ADDENDUM # 3

PROJECT: P S J A I. S. D.
Carman Elementary School & Santos Livas
Elementary School Playground Improvements
Bid # 18-19-049

ADDENDUM #3

Architect: EGV ARCHITECTS
Project Name: P.S.J.A. ISD CARMAN ELEM. & SANTOS LIVAS ELEM.
PLAYGROUND RENOVATIONS.
Project Number: 19.1.32
Date: 5/16/2019

EC1-1

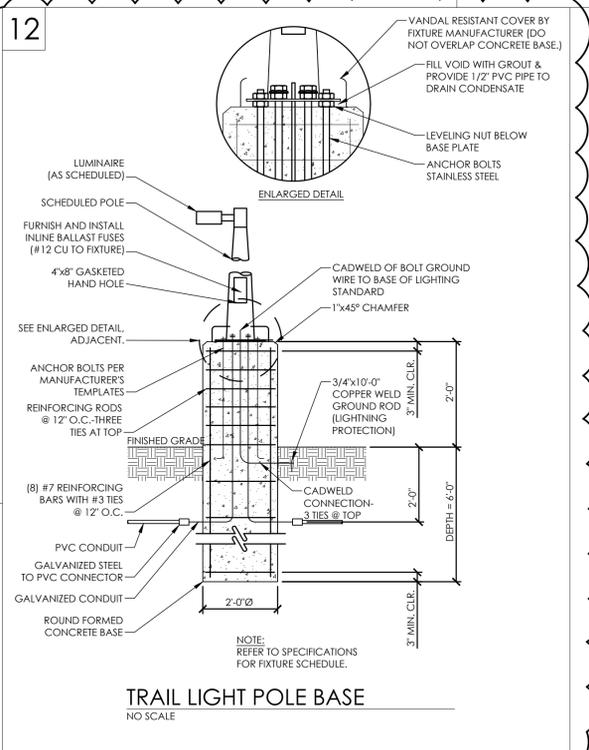
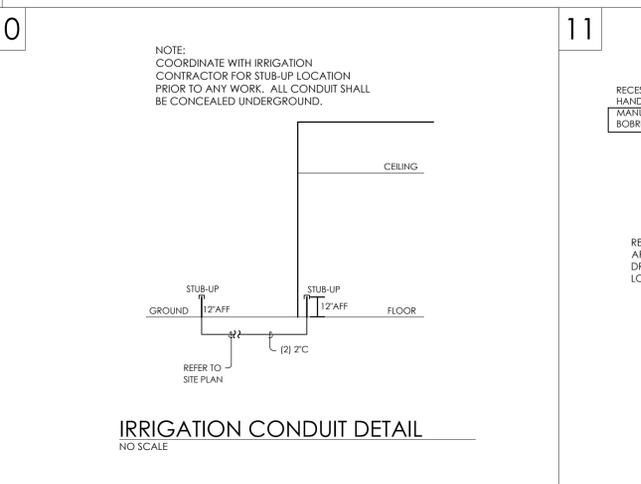
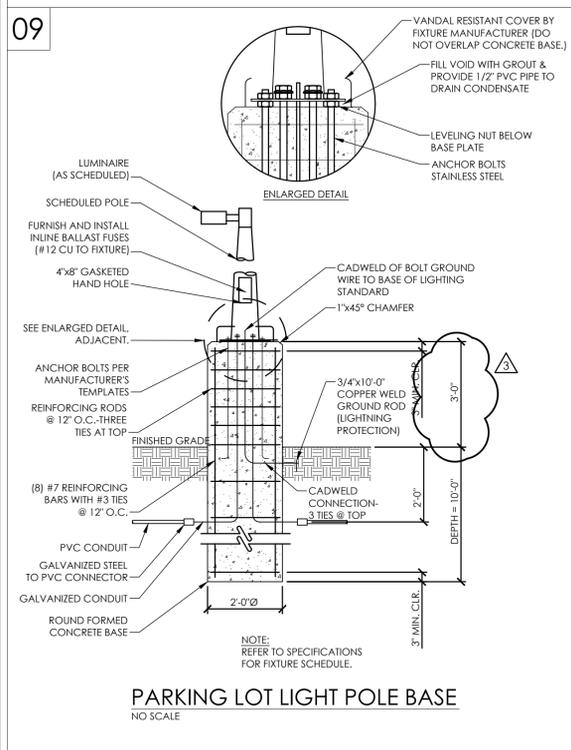
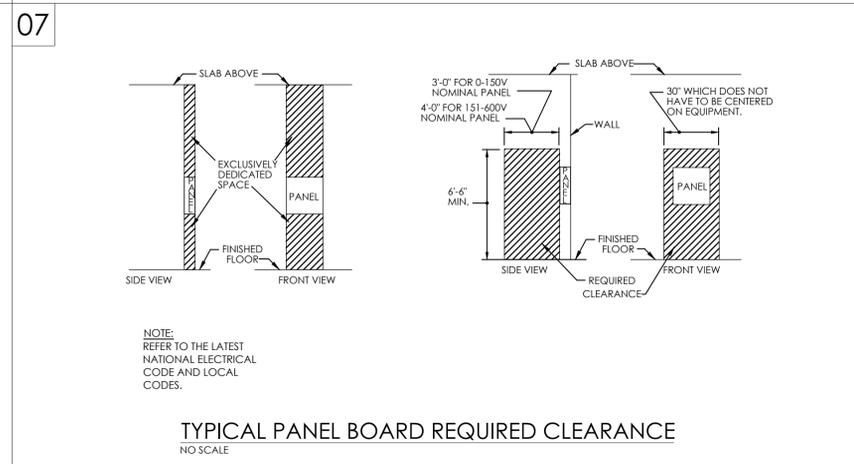
- I. Specifications: N/A
- II. General: N/A
- III. Mechanical: N/A
- IV. Electrical:
 - A. Sheet EC1.1
 - 1. Additional wallpack at restrooms, refer to attached.
 - 2. Relocated IWH-1 disconnect, refer to attached.
 - B. Sheet EC3.1
 - 1. Revised load analysis, refer to attached.
 - 2. Revised keyed notes, refer to attached.
 - 3. Revised panel schedules, refer to attached.
 - 4. Revised electrical schematic diagram, refer to attached.
 - C. Sheet EC4.1
 - 1. Revised Detail #9, refer to attached.
 - 2. Added Detail #12, refer to attached.
 - D. Sheet ES1.1
 - 1. Additional wallpack at restrooms, refer to attached.
 - 2. Relocated IWH-1 disconnect, refer to attached.
 - E. Sheet ES3.1
 - 1. Revised load analysis, refer to attached.
 - 2. Revised keyed notes, refer to attached.
 - 3. Revised panel schedules, refer to attached.

1 ELECTRICAL SCHEMATIC DIAGRAM
SCALE: NTS

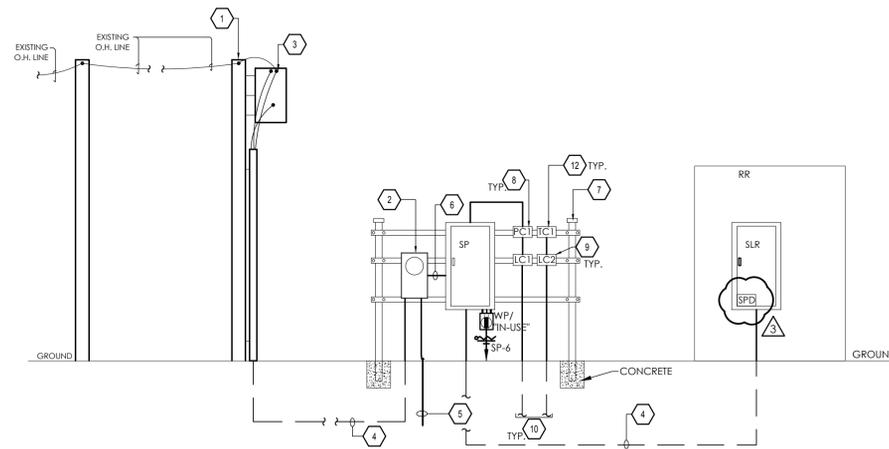
4. Revised electrical schematic diagram, refer to attached.

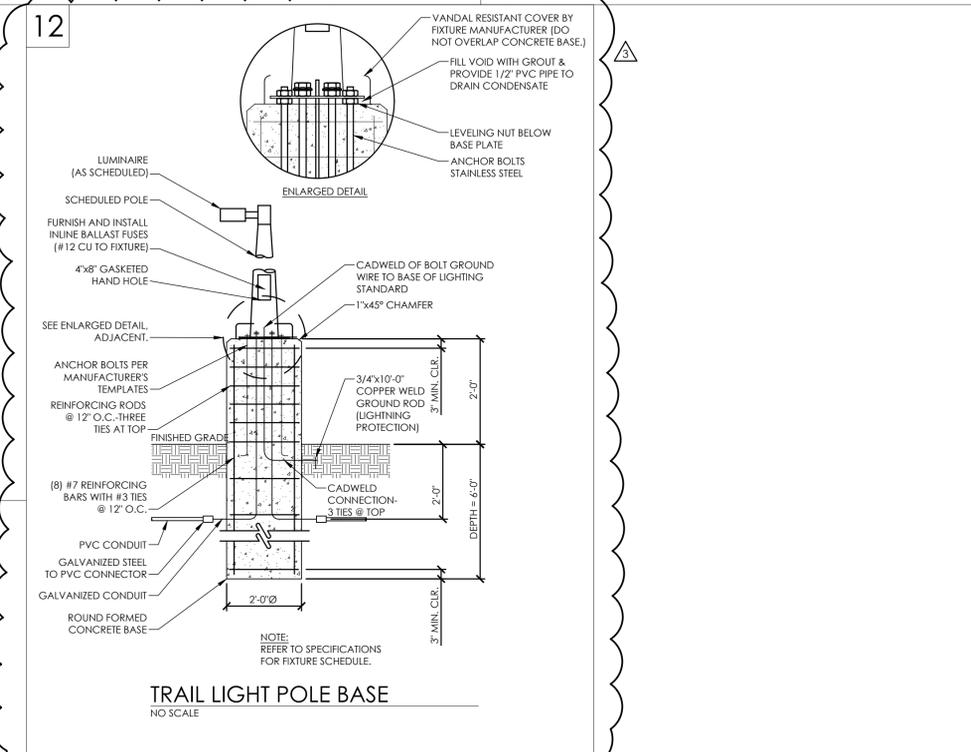
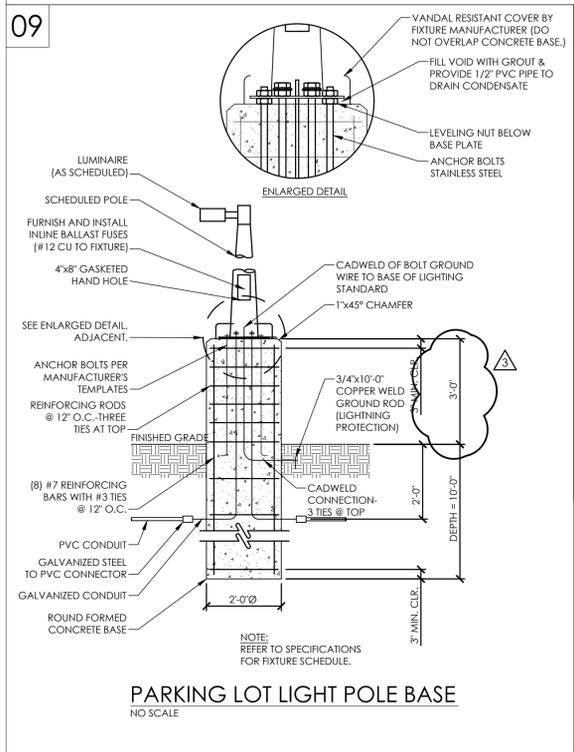
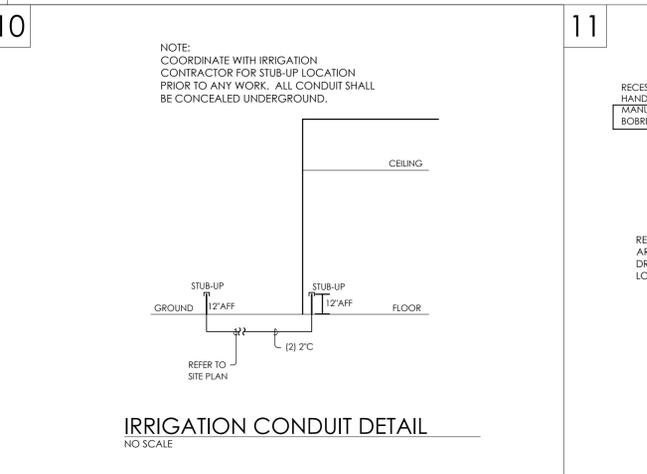
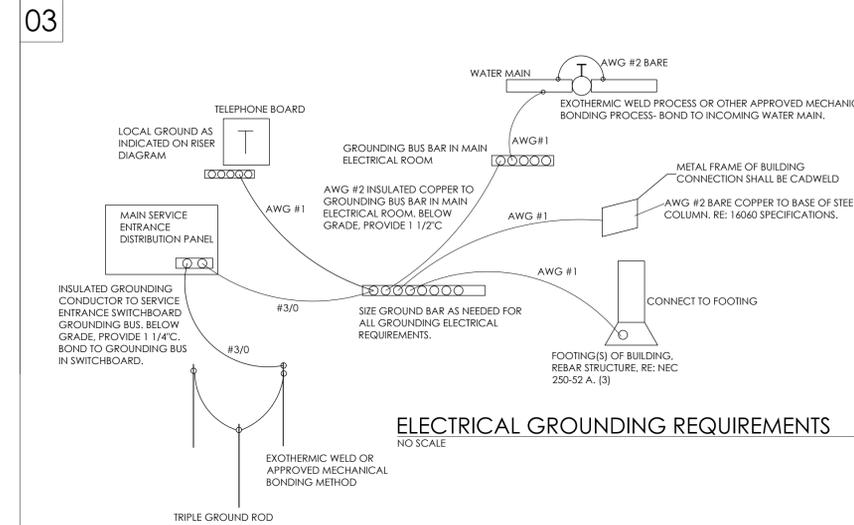
F. Sheet ES4.1

1. Revised Detail #9, refer to attached.
2. Added Detail #12, refer to attached.
